Re: State Significant Development – Kariong Sand & Soil Facility (SSD-8660)

RE: DRAFT Peer Review of Kariong Sand and Soil Supplies Air Quality Impact Assessment

Technical Acoustic Review: Noise and Vibration Impact Assessment
Kariong Sand and Soil Supplies Facilities Upgrade
90 Gindurra Road, Somersby, NSW.

RE: Traffic Impact Assessment Review – Kariong Sand and Soil Supplies Development and Light Industrial Subdivision Development – 90 and 83 Gindurra Road, Somersby

Figure 1: General concept layout

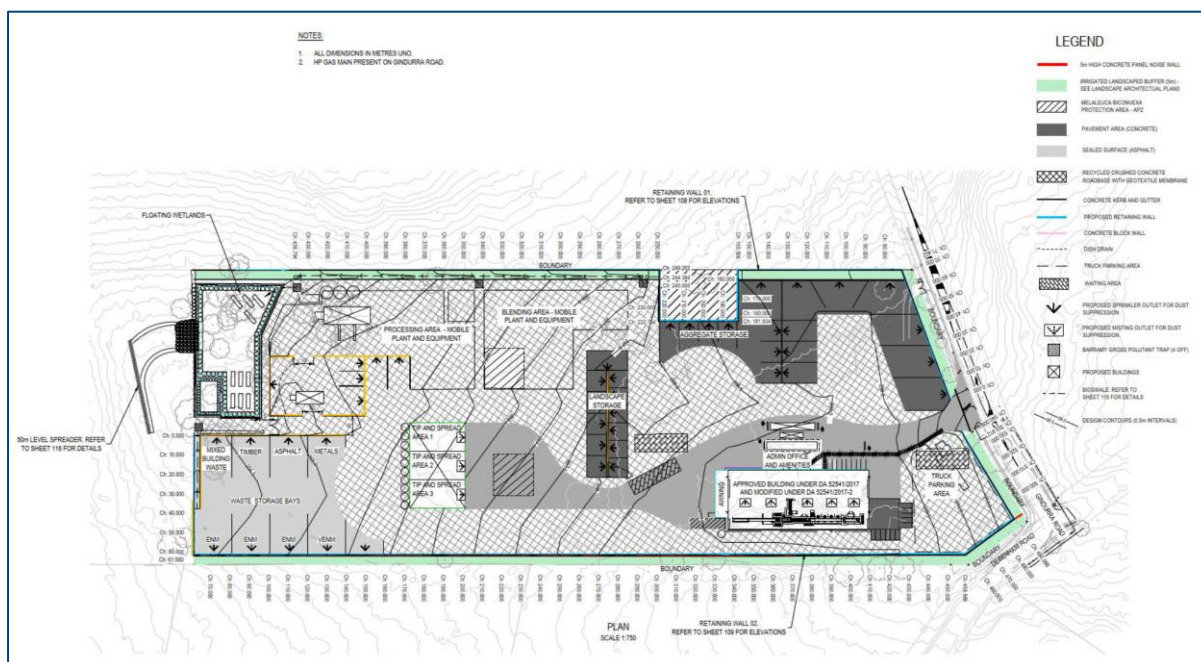
A general concept layout for the Project is presented in **Figure 1**. It is stated that the total “developed operational area on the site will be approximately 39,000 m²” (i.e. 3.9ha).

Figure 3: Gosford AWS windrose

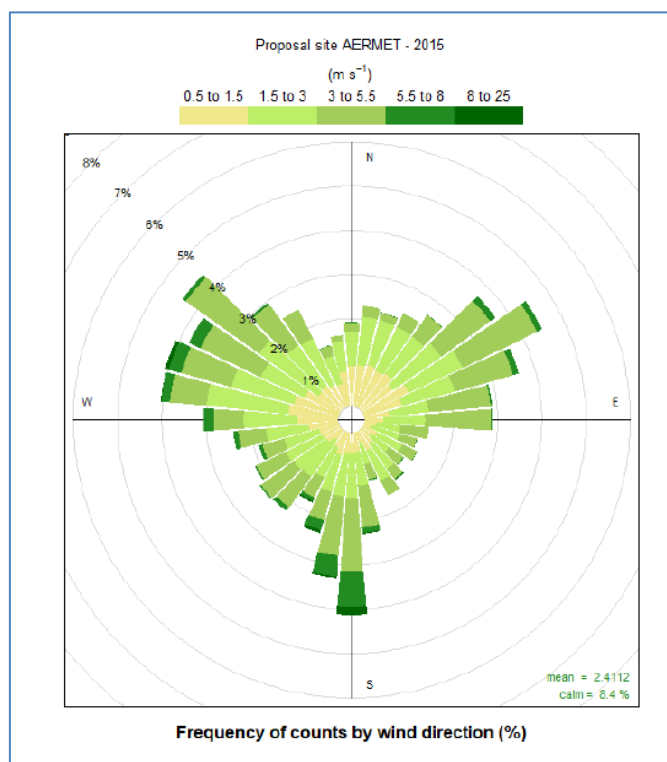
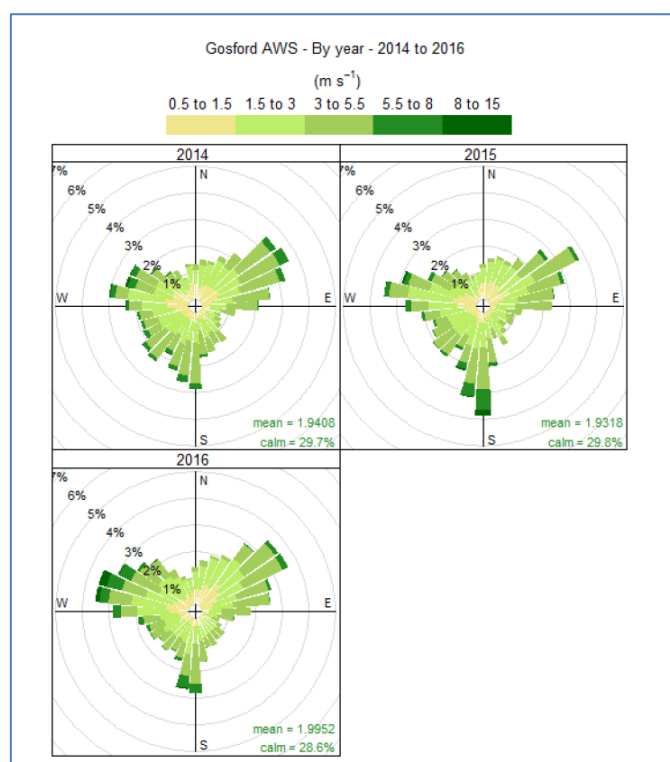
The AERMET generated windrose is presented in **Figure 2** and for comparison, **Figure 3** presents the Gosford AWS windroses. The AERMET windrose shows similar wind patterns to the Gosford data.

It is to be noted that the Gosford AWS station is located in flat terrain near sports fields, north of a large body of water, and south of a steep wooded ridge which runs approximately east-west. On the other hand, the project site is positioned on the western ridgeline or plateau at a significantly greater elevation to the Gosford meteorological station, and does not have elevated terrain to the north, or flat level terrain nearby or to the south.

Due to these significantly different geographical features, the winds at the project site will be significantly different to those as Gosford AWS. These different features will necessarily cause the project site and monitoring station to experience significant meteorological conditions, that is, wind speed and wind direction will be affected by different anabatic and katabatic processes, differing nearby land surfaces and will be subject to different southerly and northerly flow and wind speeds.

This means the AERMET data used in the air dispersion modelling is not representative of the project location. This is acknowledged in the AQIA which says *“Although the data do not represent site specific conditions (i.e. at the project site), no data is available to allow an assessment of that meteorological environment”*. It is important to note that unrepresentative meteorological data may cause invalid or incorrect dust modelling results. Meteorological modelling by the reviewer has been made for a location near to the project site, shown as “CALMET Extract” in **Figure 4**. These data can be used for a relative comparative assessment of the meteorological environment near the project site. A windrose showing the reviewer’s results is presented in **Figure 5**, and is provided to indicate the weather conditions which are more likely to be experienced near the project site as may be expected due to the geographical features near the project site. It is also noted that due to differing geographical features in the area, there will also be some difference between different locations along the plateau or ridgeline also, however these local geographical differences would be smaller than those between the project site and the location of the Gosford AWS.

Figure 5: Indicative windrose at “CALMET Extract” location, likely more representative of the project site.

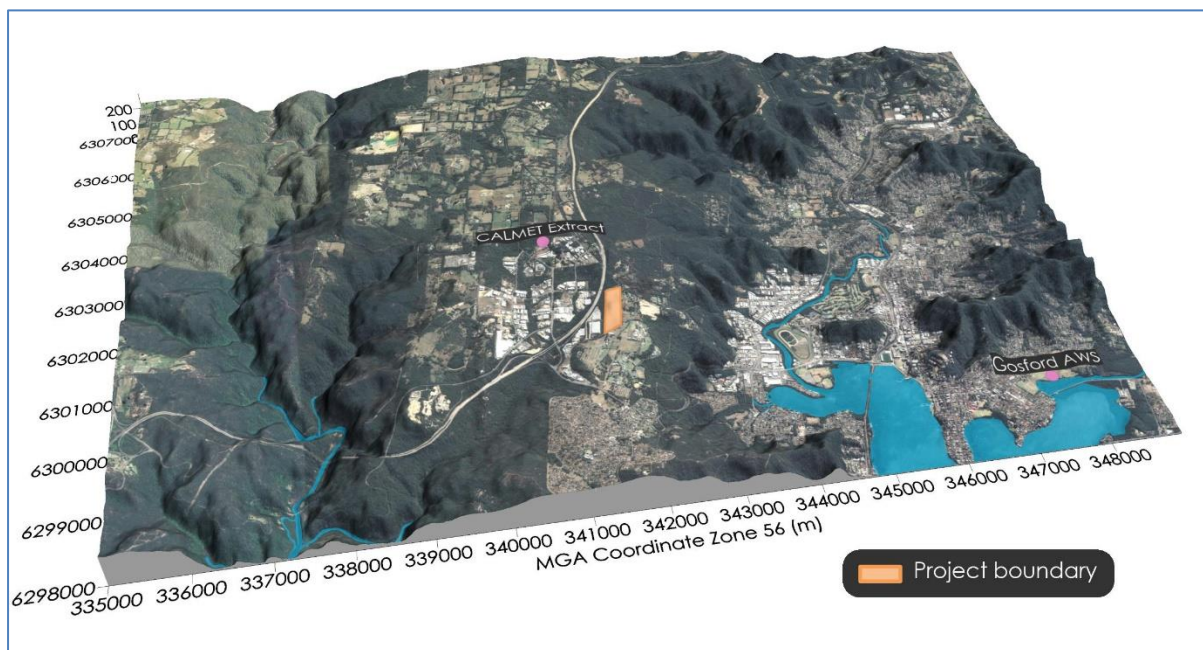
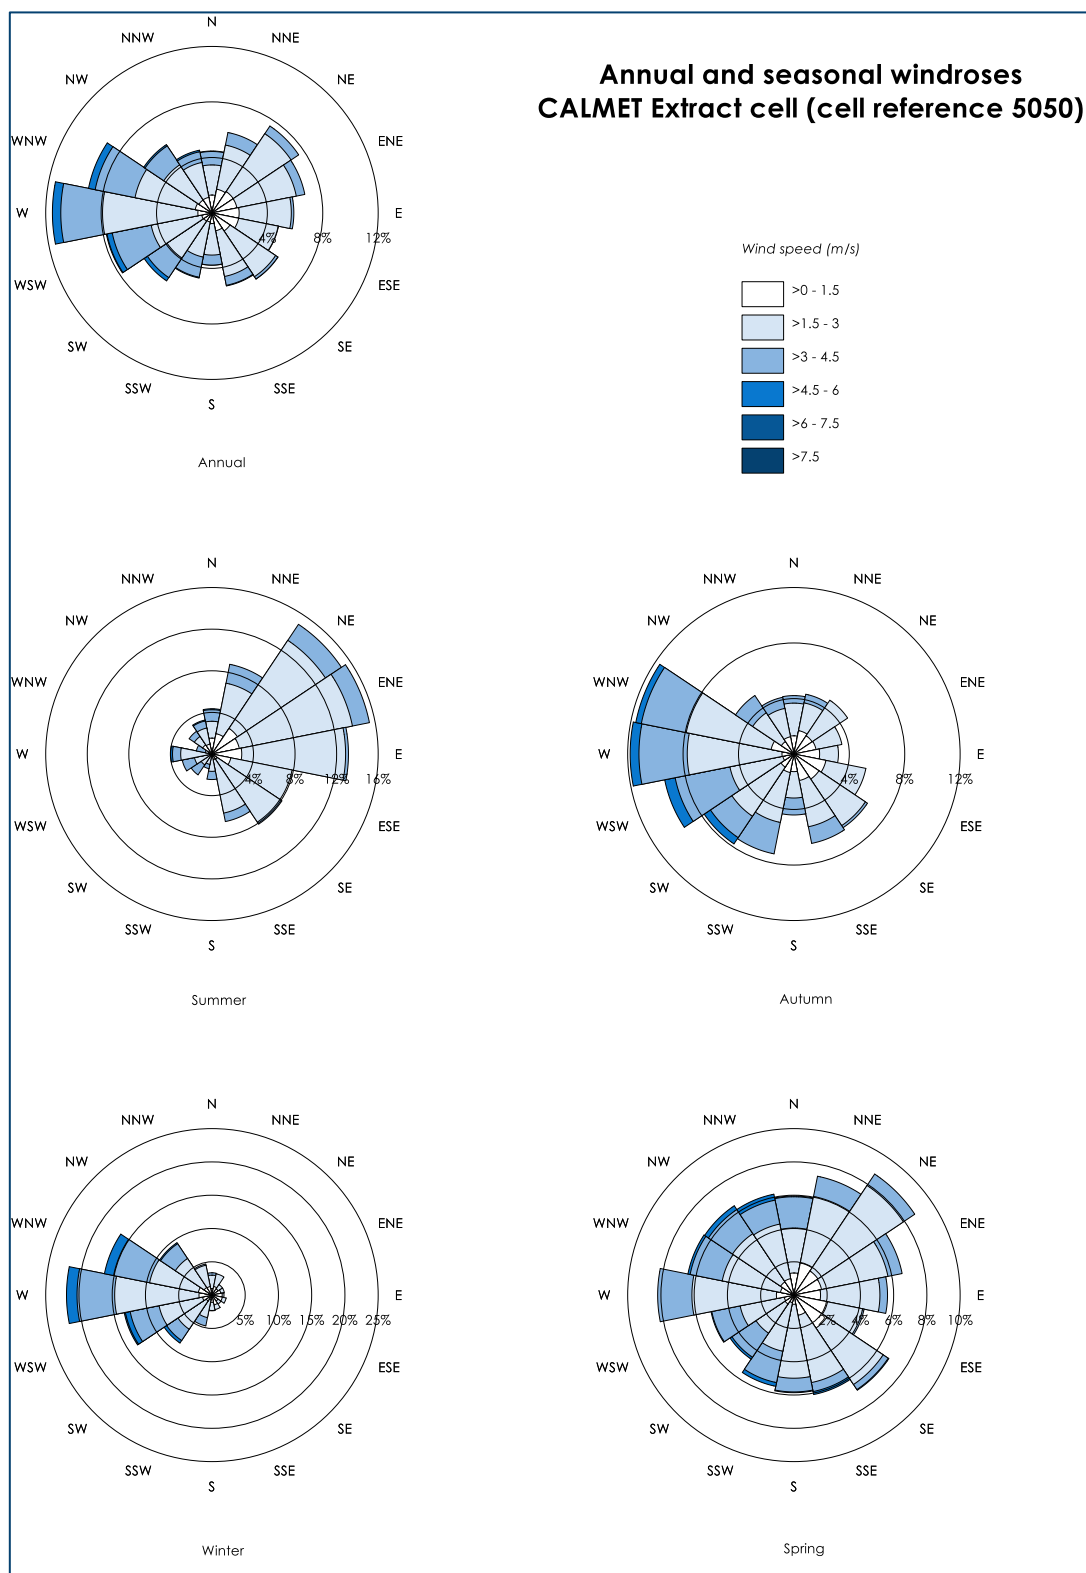
likely (as we see in the windrose), the steep wooded ridge to the north will block northerly winds, and enhance NW and NE winds (as is the case)¹ (see **Figure 4**). It is important to note that there are no such features at the project site (see **Figure 4**), hence there will be different wind conditions, and there is no reason to expect similar wind conditions at the project site to those at Gosford AWS. However, the AERMET modelling shows no significant differences between the site windrose and the Gosford AWS windrose.

The indication from the above is that relative to the modelled winds, there are likely to be less southerly winds and more westerly winds present near the project site, i.e. more winds towards the nearest receptors. This is especially the case in the winter time, which generally tends to coincide with the poorest air dispersion.

Thus, the weather inputs and model used have potential to lead to invalid or incorrect results.
